SERVICE BULLETIN REVISION TRANSMITTAL SHEET

MODEL BD-700-1A10 (BD-700)

Service Bulletin No. 700-31-026

MODIFICATION – FLIGHT DATA RECORDING-SYSTEM – INTRODUCTION OF A QUICK ACCESS RECORDER

700-31-026
Page 23 of 24

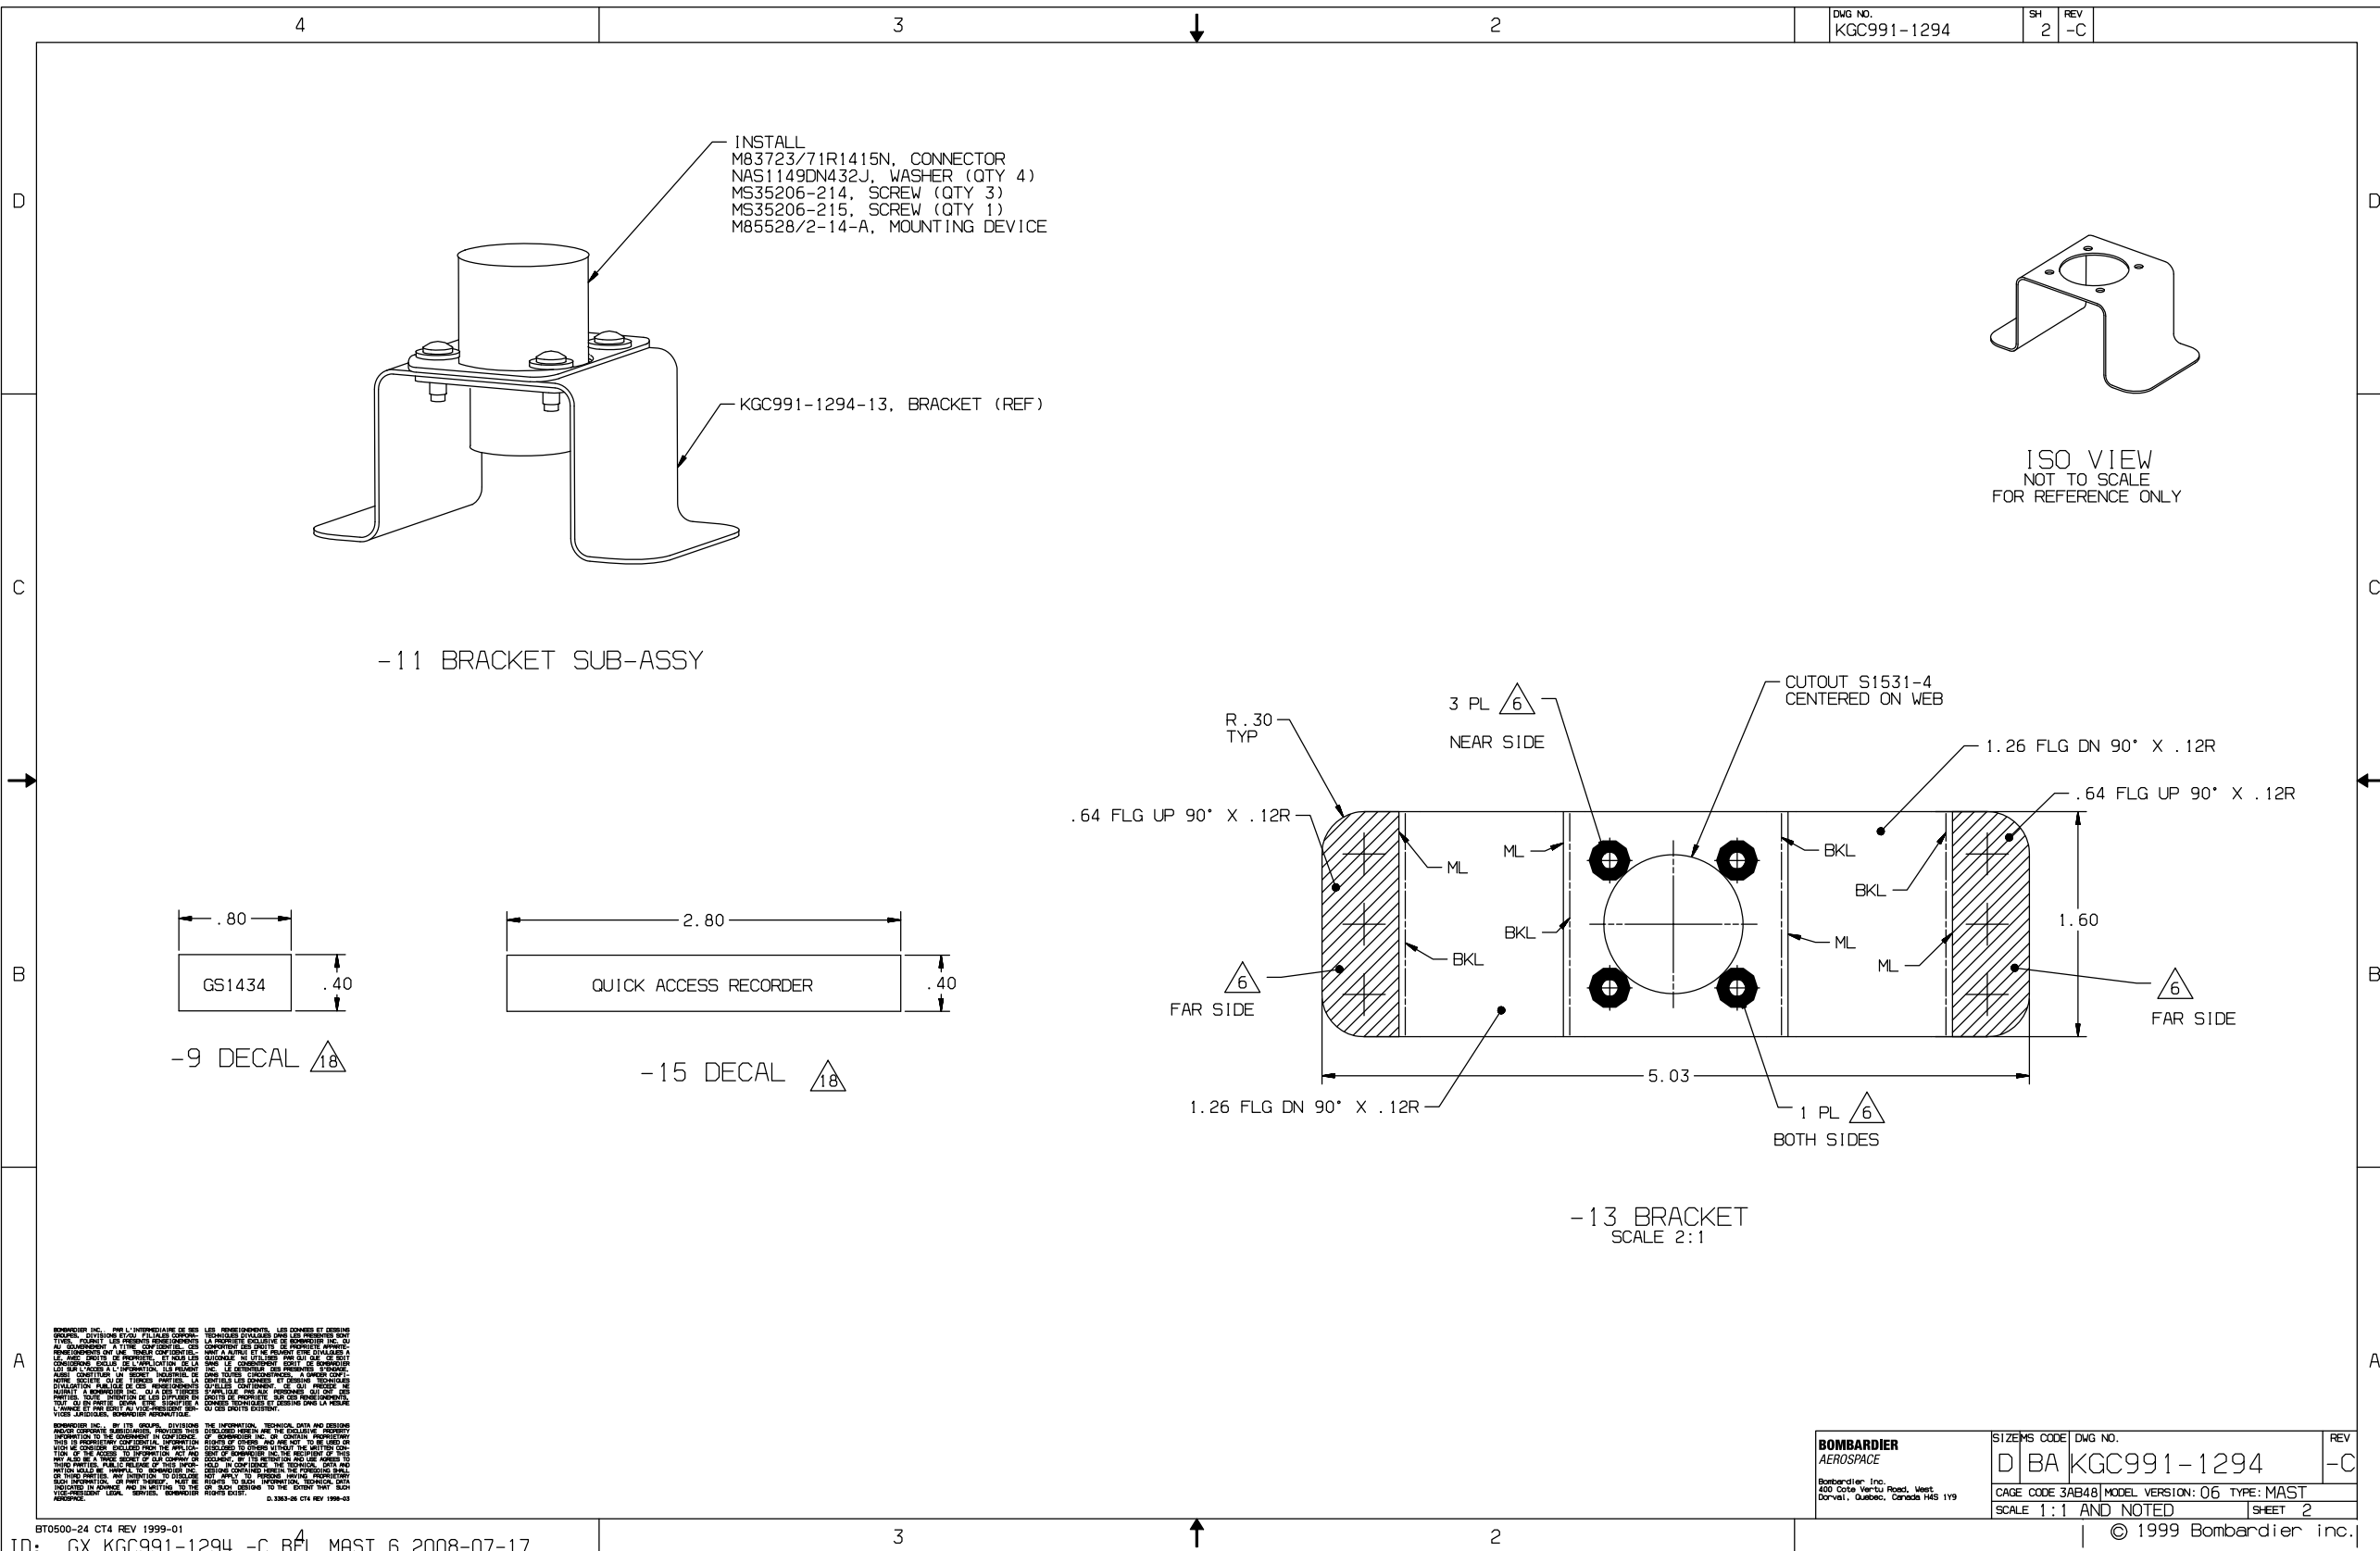
3. Change, in Paragraph 2.B.(1)(a) and other subsequent steps, the part no. of the bracket sub-assembly KGC991-1294-3 to KGC991-1294-11.
4. Change, in Paragraph 2.B.(2)(f)(iii), the part no. of the bracket KGC991-1294-5 to -13.

5. Add, in Paragraph 2.B., step (7): "Install decal Part No. KGC991-1294-15 above cut out as shown on Kit Drawing KGC991-1294. Refer to TASK 20-80-01-0400-801."

7. Change, in Paragraph 3.A., the part no. of the bracket KGC991-1294-5S to -13 or -13S.
8. Add, in Paragraph 3.A., DECAL Part No. KGC991-1294-15.
9. Replace revision B of Kit Drawing KGC991-1294 with revision C.

- (7) Install decal Part No. KGC991-1294-15 above cut out as shown on Kit Drawing KGC991-1294. Refer to TASK 20-80-01-0400-801.
 - (8) Install JB6. Refer to TASK 24-00-13-400-801
